LETTER REGARDING SEACOAST ANTI-POLLUTION LEAGUE REVIEW COMMENTS ON
THE 2003 DRAFT SITE SCREENING INVESTIGATION REPORT OF SITE 34 NSY
PORTSMOUTH ME
2/5/2004
LEPAGE ENVIRONMENTAL SERVICES

Subject: Review of December 2003 Draft *Site Screening Investigation Report for Site 34*

SAPL Input for January 8, 2004 OU4 Technical Meeting

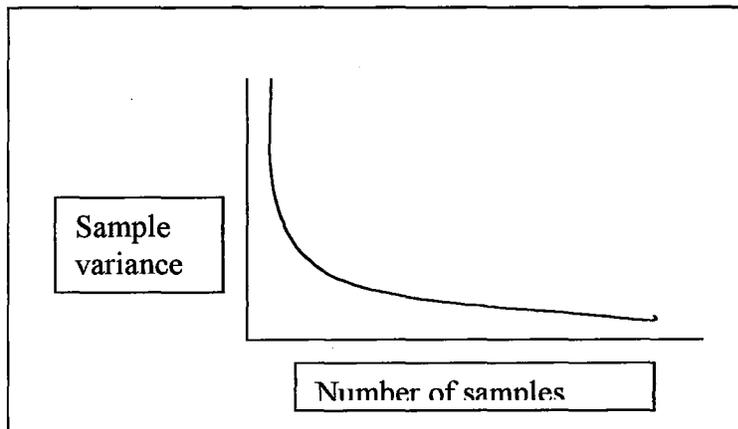
As shown above, very small sample sizes give inordinately large variances. The true population variance is only shown as the sample size increases in the figure. The number does not need to be large but when the number is very small the variance is over-estimated
